CITY PLANNING COMMISSION

- APPLICATION:**
- A. Negative Declaration
 - B. Special Permit for a drive-thru service window for a restaurant.
 - C. Variance to locate vehicle maneuvering area off-site for seven parking spaces.

PROPOSAL: The applicant is requesting the necessary entitlements to construct a 2,250 sq. ft. restaurant.

APPLC. NO. P88-034 MEETING DATE January 28, 1988 ITEM NO. 17

SITE PLAN

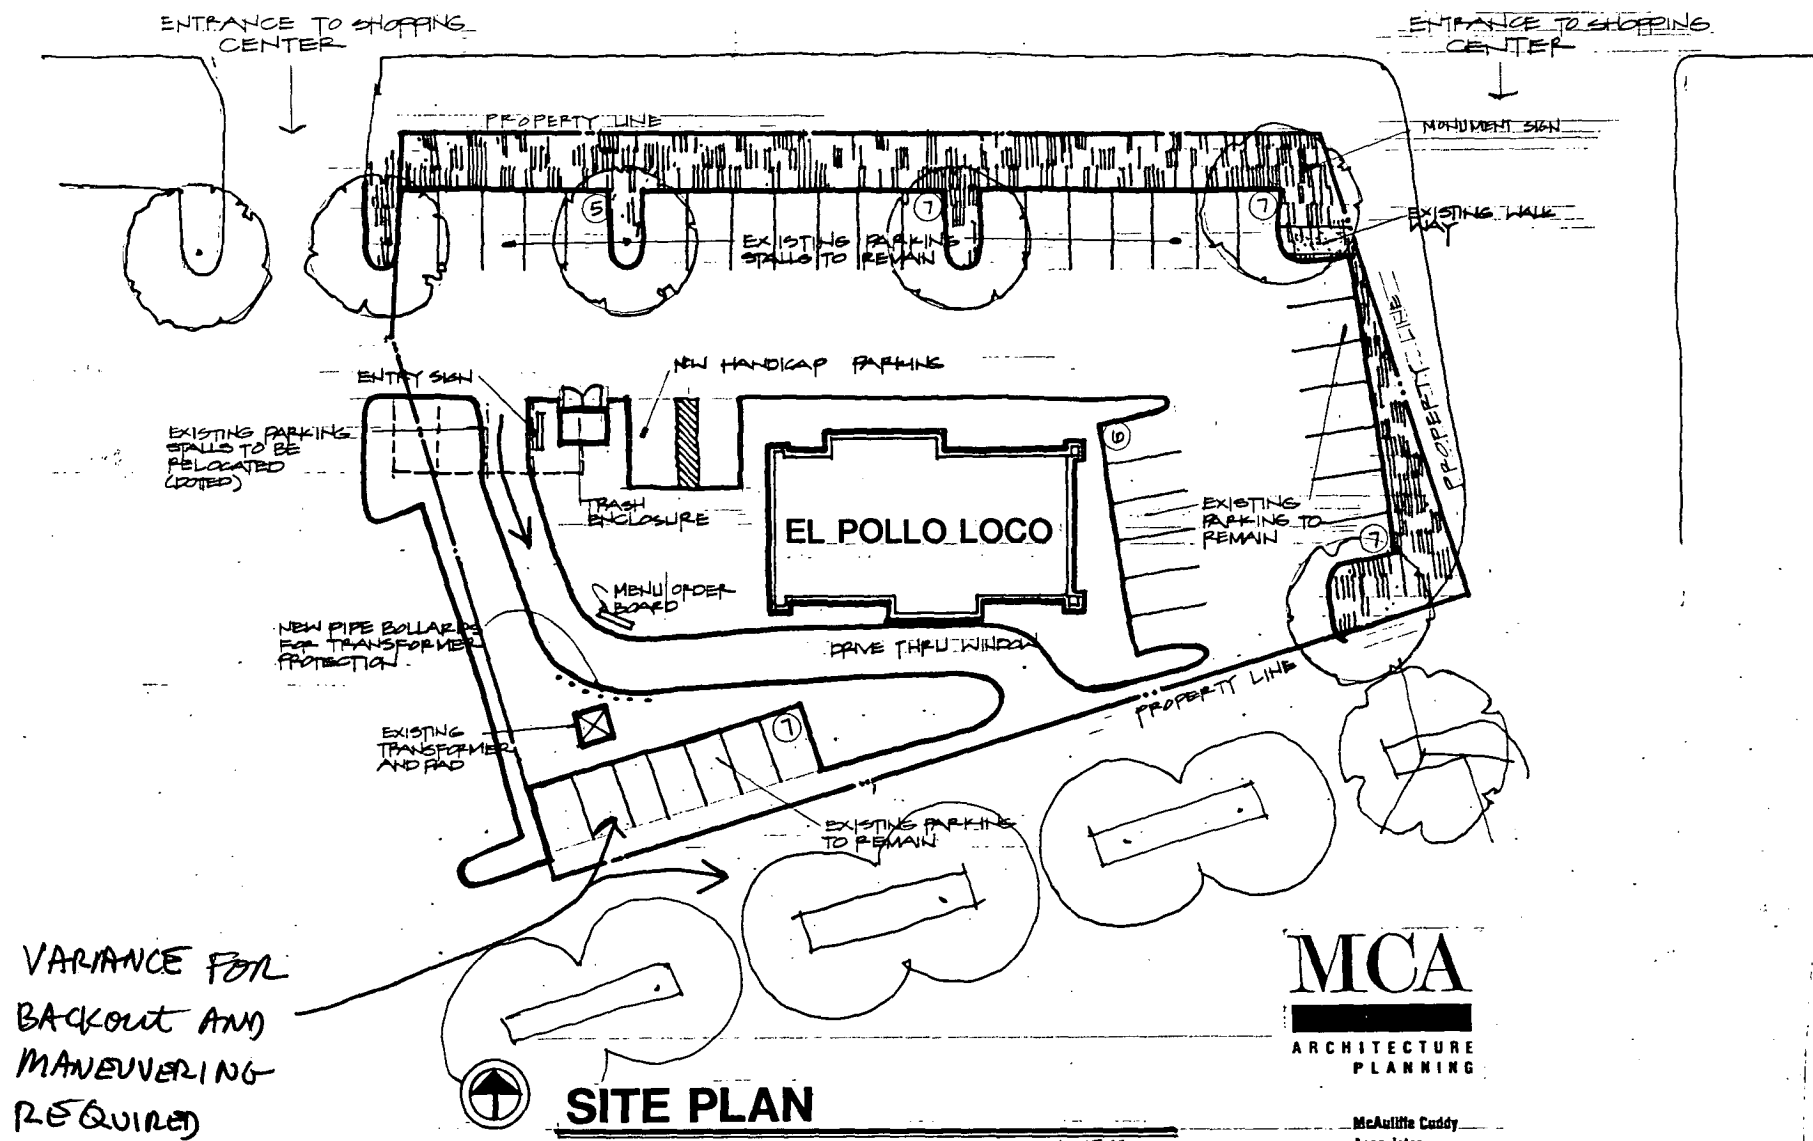
The applicant proposes to locate the required back out and maneuvering area for seven parking spaces off-site. This back out and maneuvering area would be located on Parcel 4, located adjacent to the subject site. Parcel 4 is presently developed with a shopping center.

The applicant has submitted a copy of a portion of a lease agreement between the owner of Parcel 4 and the applicant. This twenty year lease agreement specifies the applicant may use Parcel 4 for back out and maneuvering area. Staff notes, however, this lease agreement did not include the required signatures agreeing to the terms of the lease agreement by the two parties involved: Mack and Frank Associates and El Pollo Loco, Inc. Staff recommends a copy of a signed lease agreement be submitted to the Planning Director prior to issuance of a building permit. Staff has no objection to the variance request provided a signed lease agreement is submitted to the Planning Department.

According to Plans submitted, customers will enter and exit the drive-thru lane as indicated on the site plan. The Traffic Engineering Department has reviewed the site plan with respect to ingress/egress and stacking distance for automobiles in the drive-thru lane. Traffic Engineering has concluded there is adequate stacking distance and the ingress and egress via the drive-thru lane is satisfactory.

A trash enclosure is proposed as indicated on the site plan. No details have been submitted regarding the exterior building materials for this trash enclosure. Staff recommends the walls of the trash enclosure be constructed of solid masonry material with decorative exterior surface finish compatible to the proposed restaurant. Split face concrete block finish is recommended. Staff recommends trash enclosure elevations be submitted for the review and approval of the Planning Director prior to the issuance of a building permit. The trash enclosure design shall conform to the Zoning Ordinance Regulations.

Off-site access and maneuvering required for the seven parking spaces should be addressed as part of a reciprocal access agreement.

1. A copy of the signed lease agreement allowing back-out maneuvering onto Parcel 4 shall be submitted to the Planning Director for review and approval prior to the issuance of a building permit.
2. The walls of the trash enclosure shall be constructed of solid masonry material with decorative exterior surface finish compatible to the proposed restaurant. Trash enclosure elevations shall be submitted to the Planning Director for review and approval prior to the issuance of a building permit.
3. A sign program shall be submitted to the Planning Director for his review and approval prior to the issuance of a sign permit.
4. Directional signs to the drive-thru window shall not exceed four square feet of sign area.

REAR ELEVATION

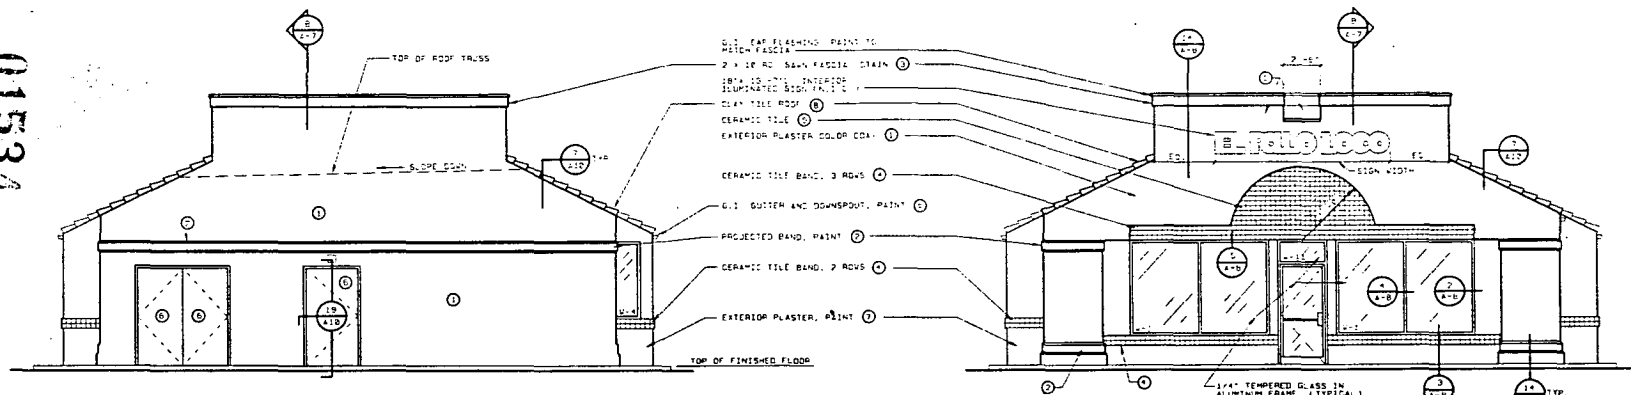
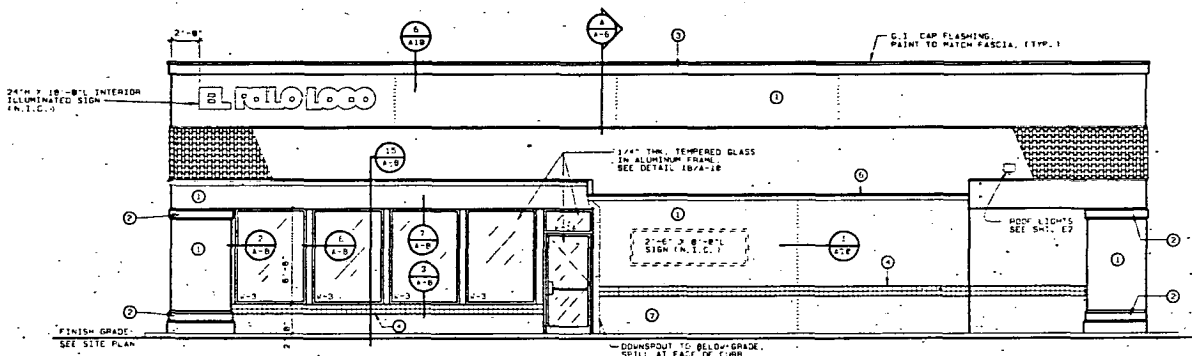
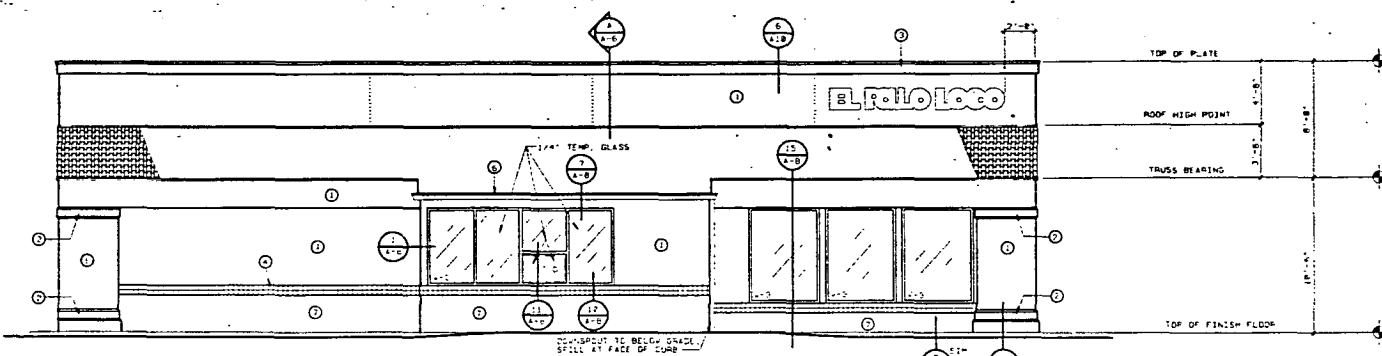
The elevations submitted indicate the exterior building materials will be ceramic tile, plaster and wood trim with a clay tile roof. The existing shopping center buildings are constructed of stucco and tile. Staff finds the proposed building elevations and materials to be satisfactory and compatible with the existing building elevations and materials of the shopping center.

Three attached interior, illuminated signs are proposed for the south, north and east elevations. These signs range in size from 18" - 24" in height to 13' - 18' in length. The sign ordinance allows a total of two attached signs not to exceed a total of 195 square feet of sign area.
